LAND NORTH OF NEW BATH ROAD, TWYFORD

Proposed Development Related Highway Works

Stage 1 Road Safety Audit
Prepared on behalf of David Wilson Homes

Gateway RSE ref: SG/WP/2208-07 RSA1 v1.2

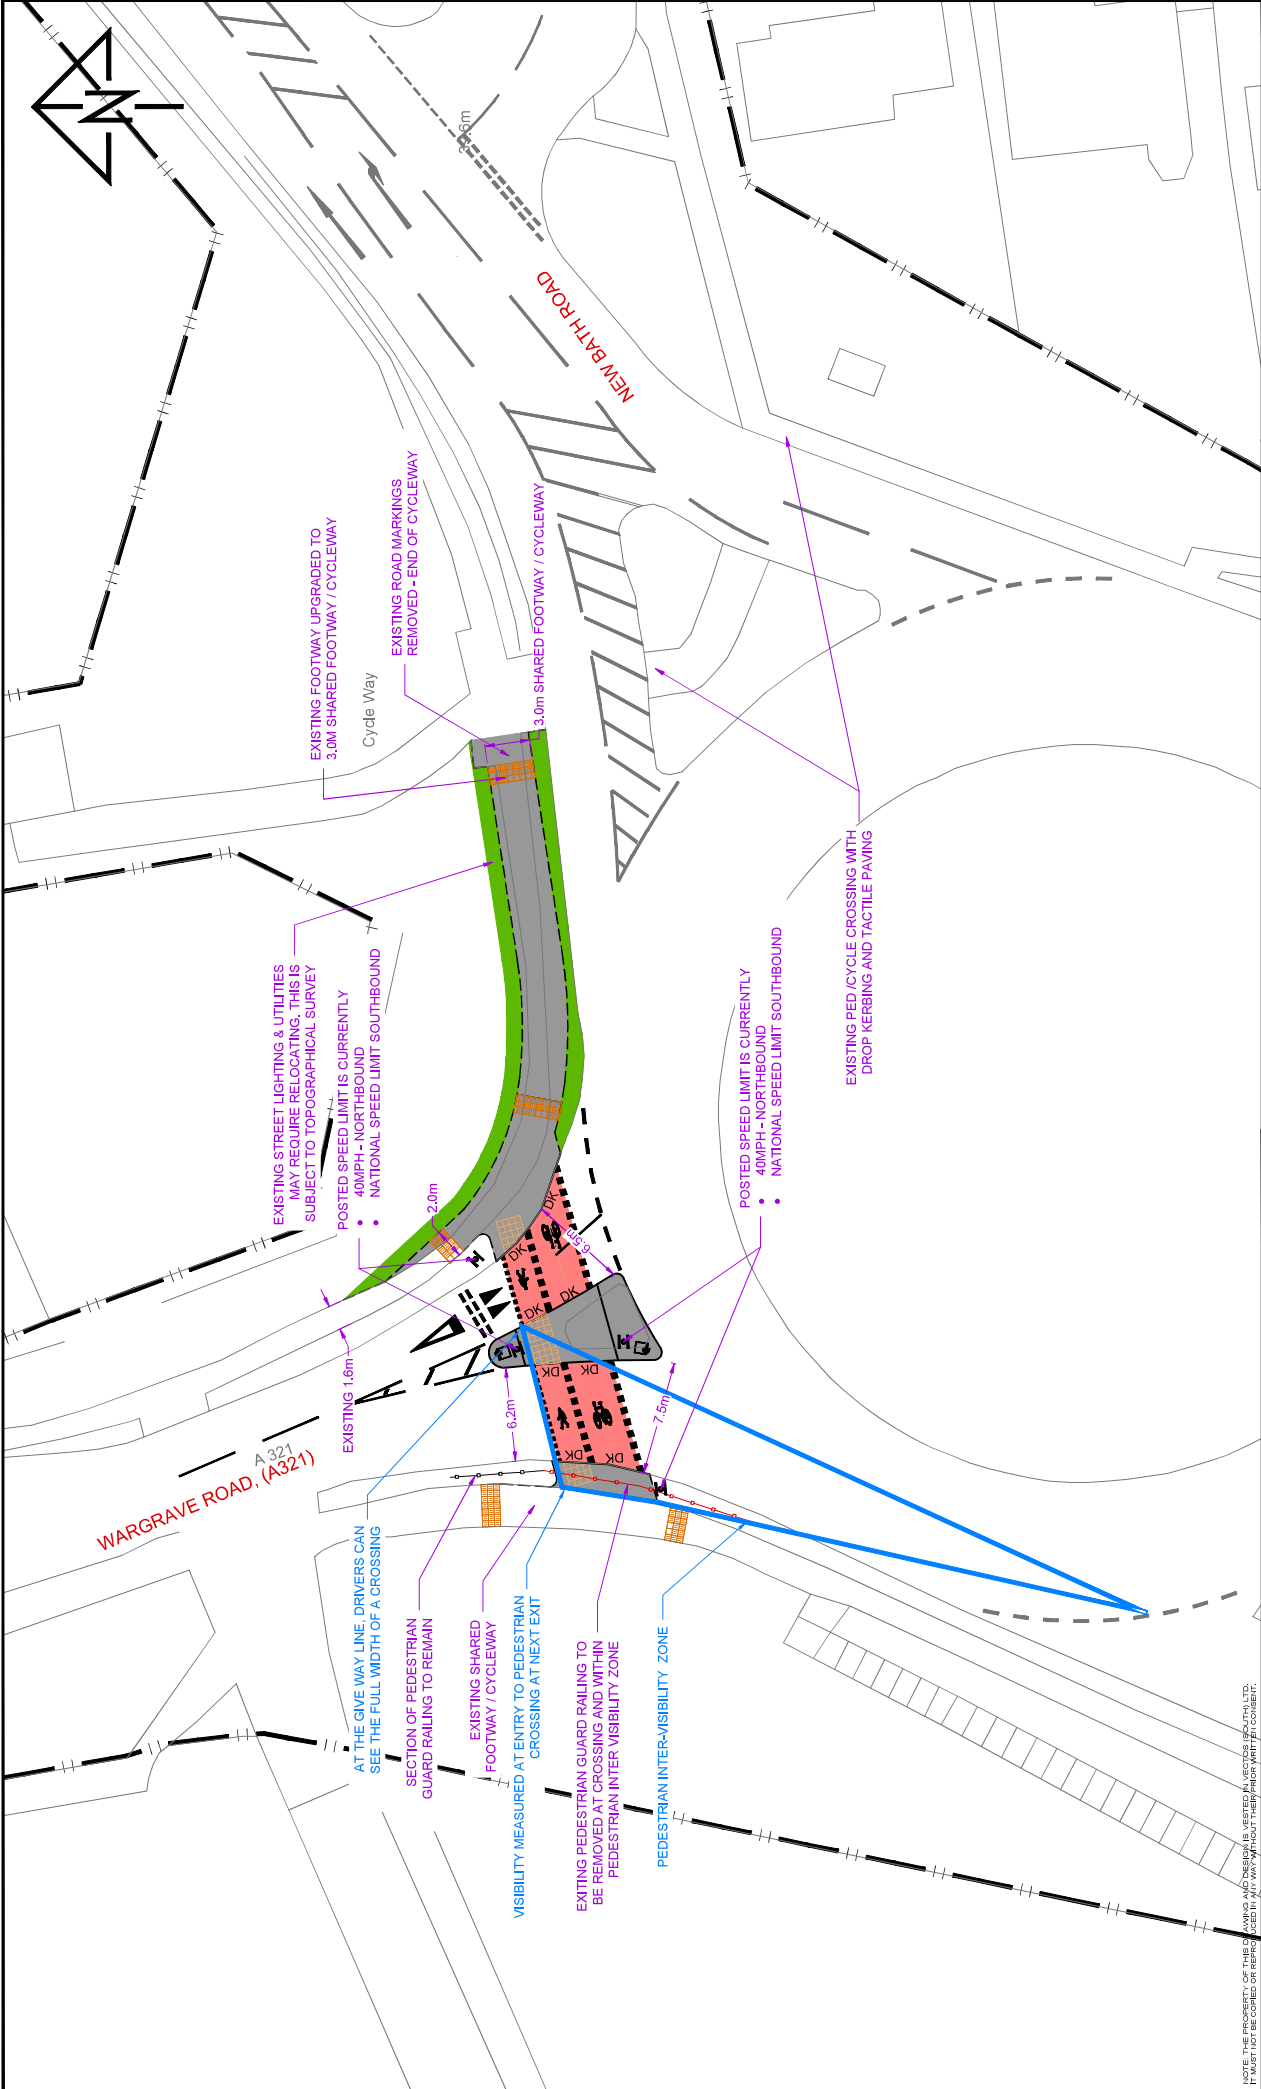
The audit team is concerned that traffic volumes on the Wargrave Road, combined with the relatively low conspicuity of the proposed cycle/pedestrian priority crossing (compared with a zebra crossing, for example), may result in drivers of motorised vehicles failing to give way, leading to vehicles striking pedestrians and cyclists.

Conspicuity of the proposed parallel cycle/pedestrian crossing on Wargrave Road should be increased.

2.6	Conspicuity of the proposed parallel cycle/pedestrian crossing on Wargrave Road should be increased.	Designers' response: We disagree, on the following grounds - The raised coloured surfacing provides a tonal contrast to both pedestrian, cyclists and drivers. The crossings points are indicated by contrasting coloured tactile surfaces. Combined with signing and

RSA Decision Log				
Item No.	RSA Recommendation	Design Organisation Response	Overseeing Organisation Response	Agreed RSA Action
		lining makes the proposal prominent to all user groups. - The raised table work as a traffic calming measure. - The design, location of the crossings has been designed in accordance / are consistent with LTN 120 guidance. - The RSA stage 1 has raised no issues with Road Signs, Carriageway Markings and Lighting. However, signage may be provided if deemed necessary following discussions with the local highway authority during the detailed design stage.
